AEP-NRC-2015-22
10 CFR 50.4

Donald C. Cook Nuclear Plant Units 1 and 2
Compliance with March 12, 2012, NRC Order Regarding Mitigation Strategies for
Beyond-Design-Basis External Events (Order Number EA-12-049)

1. Affirmation
2. Donald C. Cook Nuclear Plant Unit 2 Compliance with U. S. Nuclear Regulatory Commission Order EA-12-049
3. Responses to Interim NRC Staff Evaluation Items and NRC Audit Items
4. Status of Overall Integrated Plan Unit 2 Open Items Shown as "In Progress" in February 2015 OIP Update

Donald C. Cook Nuclear Plant Unit 2 Compliance with U. S. Nuclear Regulatory Commission Order EA-12-049

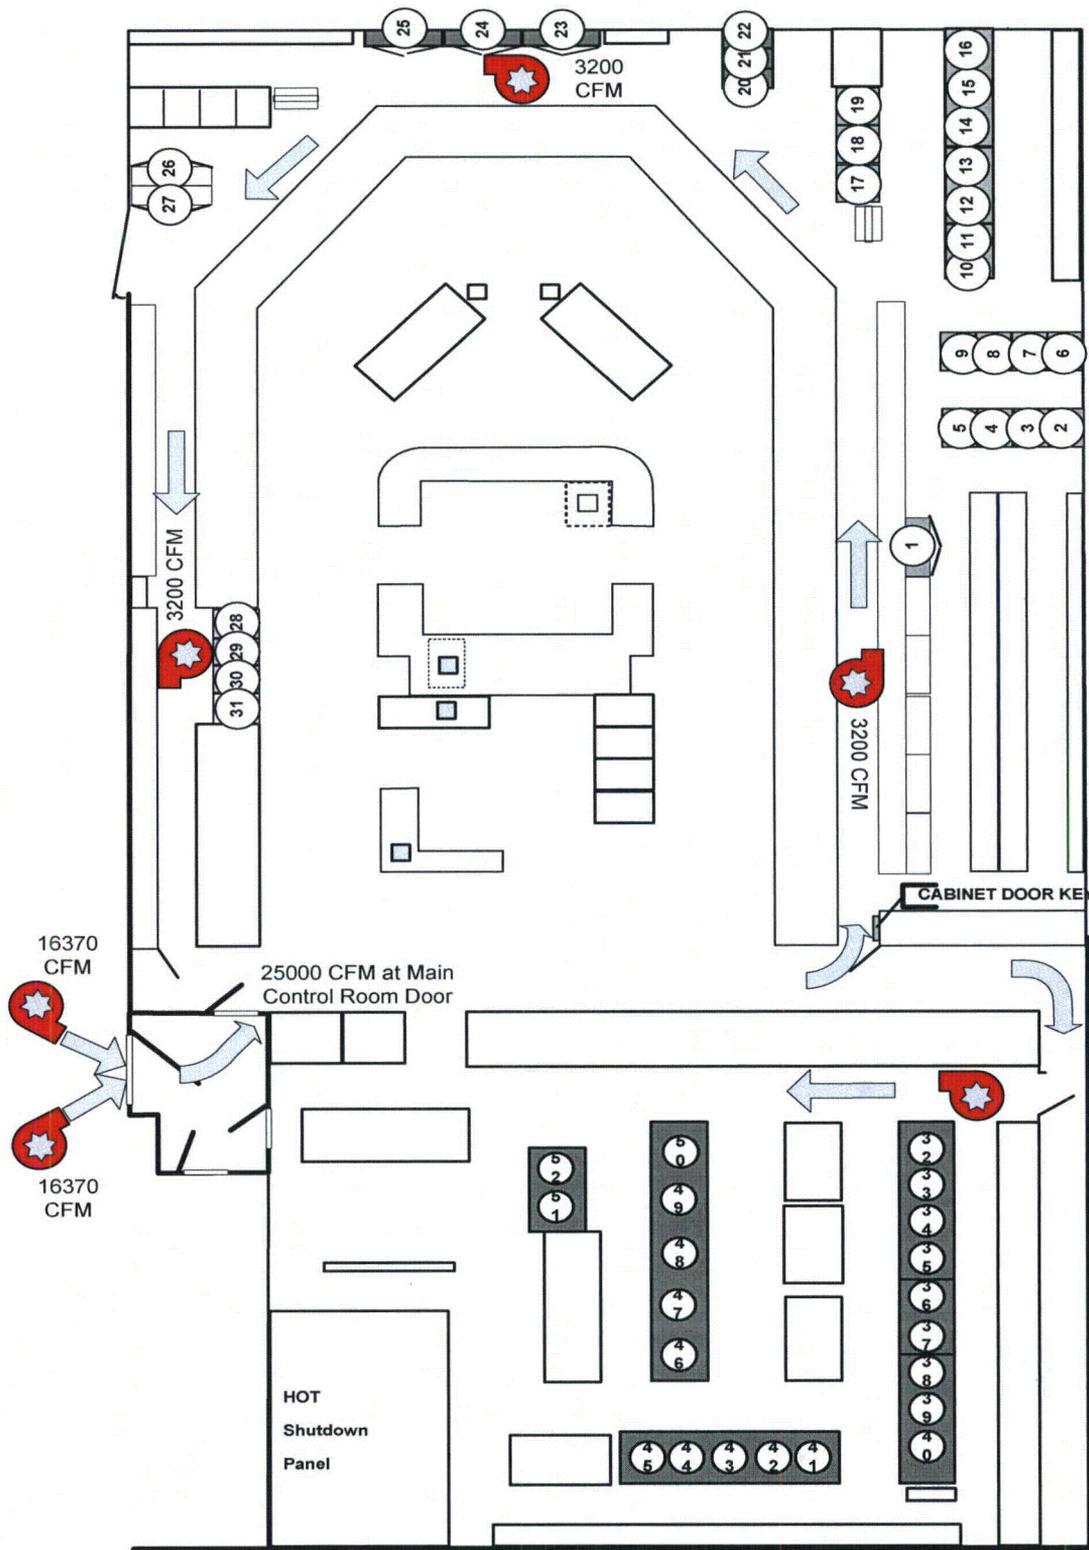
Currently, CR instrumentation cabinet doors are opened as a 30-minute time-credited-action in the procedure for responding to loss of all AC power (1/2-OHP-4023-ECA-0.0). The applicable procedure step is designed to open the cabinet doors as soon as possible. Vital instrument cooling is assured if the cabinet doors are opened within 30 minutes from loss of all AC power. This action ensures adequate instrument cabinet cooling during the four-hour SBO response.

Since the postulated ELAP exceeds four hours, the evaluation described below was performed to determine what actions would be needed to provide adequate CR ventilation during the FLEX Phase 1 and Phase 2 response. Based the evaluation, the FSG for FLEX equipment staging (12-OHP-4027-FSG-501) directs installation of temporary fans similar to the fire protection program based response for loss of CR ventilation. The sketch provided at the end of this response shows the approximate fan locations.

The acceptability of this action was determined by qualitatively extrapolating the results of the calculation for CR temperatures during a postulated fire event. This calculation used a GOTHIC model and showed a nominal 117°F maximum resultant CR temperature with a similar temporary fan flow rate. The GOTHIC time transient model served to verify that adequate time existed to install and energize the temporary fans. The following simplified steady state computation validates that the CR temperature of 117°F is reasonable given a 104°F turbine building temperature.
